DESIGN REVIEW

JOHN STREET APARTMENTS

975 JOHN STREET LLC | ANKROM MOISAN ARCHITECTS

DPD PROJECT NO: 3007906 JULY 20, 2011

DESIGN REVIEW BOARD RECOMMENDATIONS

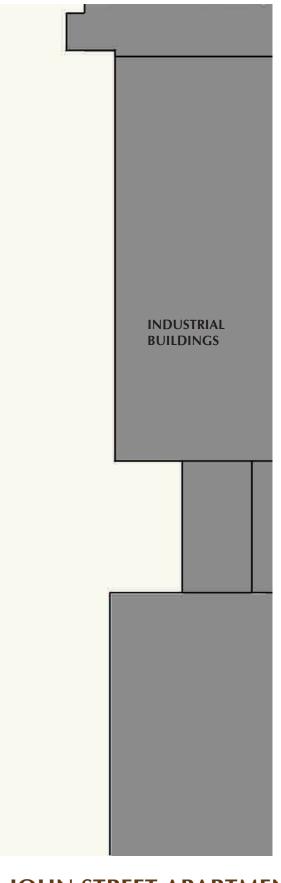
GUIDELINE	RECOMMENDATION	RESPONSE		
A-4: South Lake Union Guideline (augmenting A-4)	The retail areas are proposed below an overhang on the east-facing façade. The applicant should design these areas to have clear sight lines, good lighting, and create good connections between the sidewalk and the retail areas.	space. A setback has been provided in front		
A-5: Respect for Adjacent Sites: Buildings should respect adjacent prop- erties by being located on their sites to minimize disruption of the privacy and outdoor activities of residents in adjacent buildings.	The Board noted concerns with the prox- imity of proposed residential units to the units across the alley to the west.	The massing of the project has been revised to an L-shape, which allows for a larger courtyard and minimal units facing Rollin Street.		
A-7: Residential Open Space: Residential projects should be sited to maximize opportunities for creating usable, attractive, well-integrated open space.	The Board expressed concern that the open space at grade in the small court- yard could be easily shadowed by future development to the south. In addition to outdoor open space, the Board also advised that the applicant should group internal common areas, in order to encourage residents' use of the common areas.	The massing of the project has been revised to an L-shape, which allows for a larger courtyard facing the alley and the southern portion of the site. The internal common space has been grouped together where an open lobby with leasing office and mail- room leads through an open amenity room and out to the courtyard.

A-10: Corner Lots: Building on corner lots should be oriented to the corner and public street fronts. Parking and automobile access should be located away from corners.	The applicant had shown a glass corner element in an earlier version of the design review packet. The Board agreed that maximum glazing would provide better light to the small internal spaces within the building.	The corner lounge has been removed from the project and the massing of the project has been revised. The main entrance to the building is located on the corner of John Street and Terry Avenue North. The entrance can be accessed from both streets and will consist of as much glazing as pos- sible to create an open and inviting entry.		
B-1: South Lake Union Guideline (augmenting B-1):	The Board noted that the rooftop design should include consideration for existing and future surrounding buildings, which could be twice as tall as the proposed development. The rooftop should be designed to be visually interesting and all mechanical equipment screened from potential adjacent residents' views.	Pedestrians will enter the building at the corner of the site and cars will enter the building from the alley. Modulation of the building occurs at ground level along John Street and Terry Avenue North and on the upper levels of the building along Terry Avenue North. The massing and design of the building reflect the adjacent industrial buildings and the new construction. The roof deck size is limited by building code requirements but will include landscaping and trees for visual interest and all mechani- cal equipment will be screened.

C-1: South Lake Union Guideline (augmenting C-1):		The design of the building reflects the adjacent buildings in the neighborhood through massing and materials. A desired goal for the project is to retain the existing brick along Terry Avenue North. The exist- ing garage walls of the site will be reused for shoring. Water from the roof will be circulated to the landscaped areas of the common courtyard and will become part of the design of the planters.

GUIDELINE	RECOMMENDATION	RESPONSE
7	C-2: South Lake Union Guideline (augmenting C-2):	The Board noted that the proposed development should reflect nearby new and old context.	Please refer to previous responses regarding these comments.
8	D-2: Blank Walls: Buildings should avoid large blank walls facing the street, especially near sidewalks. Where blank walls are unavoidable they should receive design treatment to increase pedestrian com- fort and interest.	The Board noted that the proposed blank walls at the south property line should include contrasting color and/or surface treatment. These walls may be visible for a long time before develop- ment occurs on the parcel to the south.	The south concrete wall will include joints/ patterns consistent with the building design above and a metal panel at the slab edge will help to define the separation between the residential and garage levels.
9	D-5: Visual Impacts of Parking Structures: The visibility of all at-grade parking structures or accessory parking garages should be minimized.	The Board expressed concern with the potential visual impact of the northwest corner of the parking garage on the pedestrian environment.	The elevation of Level 1 has been lowered to meet building code requirements, reduc- ing the amount of blank wall at the North- west corner. The concrete wall will include joints/patterns to align with the materials in the building above and building signage will be located at the Northwest corner.

10	D-7: South Lake Union Guideline (augmenting D-7):		Lighting will be installed along the al- ley adjacent to the garage entries, at the building entry, at the common courtyard, and the private patios along the street. The common courtyard and roof deck can only be accessed from within the building and is protected from the street.
11	D-10: Commercial Lighting: Appropriate levels of lighting should be provided in order to promote visual interest and a sense of security for people in commercial districts during evening hours.	Comments reflect those found in response to A-4.	Please refer to previous responses. Lighting will be installed along the alley adjacent to the garage entries, at the building entry, at the common courtyard, and the private patios along the street. The building mass- ing is stepped back from adjacent properties allowing for natural light and air.
12	E-1: South Lake Union Guideline (augmenting E-1):	The landscaping and streetscape should reflect the Rollins Street Flats streetscape and continue the theme to this block.	Street trees and plants consistent with Rollin Street will be planted along John Street. There will be planting along Terry Avenue North that conforms to the Terry Avenue North design Guidelines and a large land- scaped courtyard is located at ground level.

13	E-2: South Lake Union Guideline (augmenting E-2): Consider integrating artwork into pub- licly accessible areas of a building and landscape that evokes a sense of place related to the previous uses of the area.	Landscaping at the alley near the green wall should be low profile to prevent potential conflicts between cars and pedestrians at the alley intersection. The landscaping should also be designed to fully camouflage the blank wall.	We are no longer proposing landscaping at the northwest corner or along the alley due to the northern exposure and lack of light. Please refer to previous comments. Land- scaping from the common courtyard will be visible from the alley and provide visual interest.
